ADDENDUM TO RFP DOCUMENTS

SOLANO COMMUNITY COLLEGE	ADDENDUM #03
	Project: Solano Community College District Building 100 Generator Project (Project # 18-003)
	Date: November 10, 2017

ITEM NO. 3 – Revised Plan Sheet A0.5 – Site Details

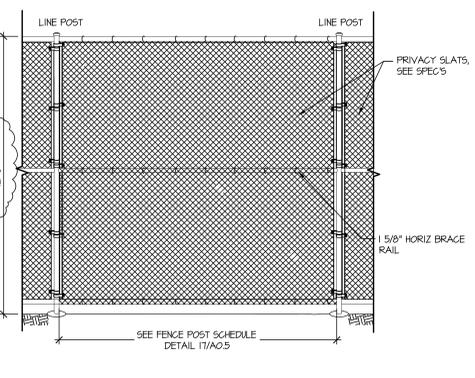
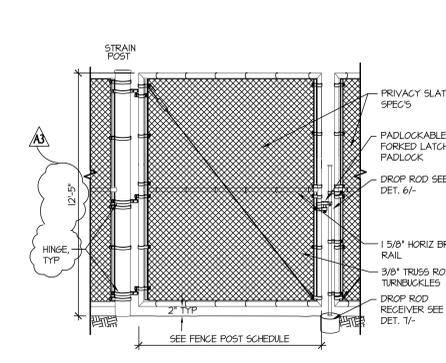
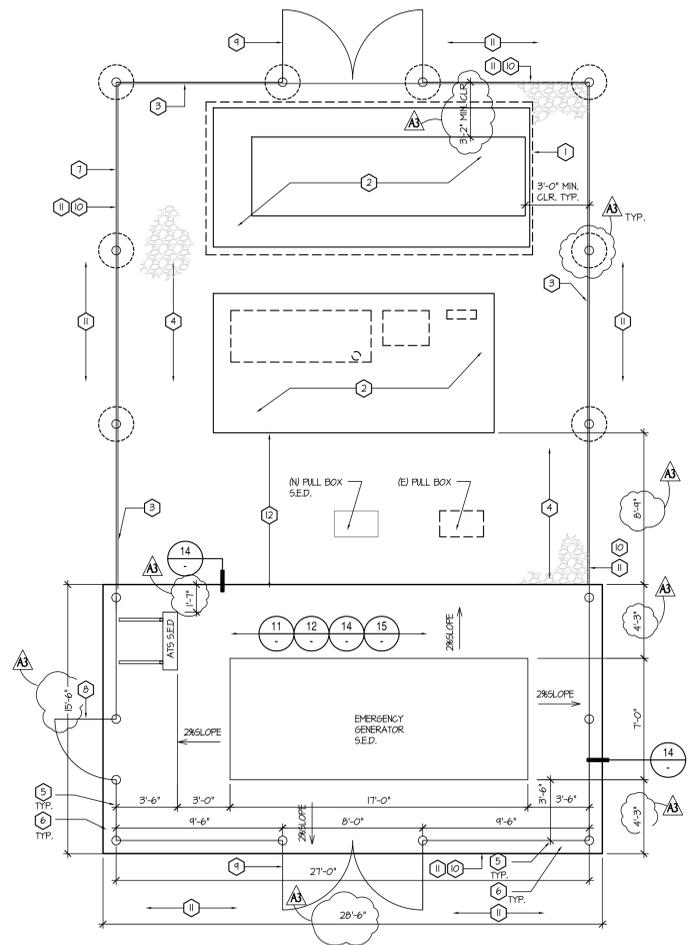
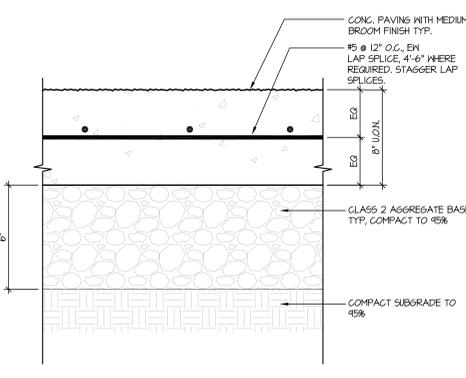
Revision to plan sheet A0.5, including changes to overall height of chain link fencing from 10’-0” to 12’-5” and minor revisions for concrete pad. Revised plan sheet A0.5, attached below, shall supersede all prior versions and concrete pad details and dimensions included in electrical drawings.
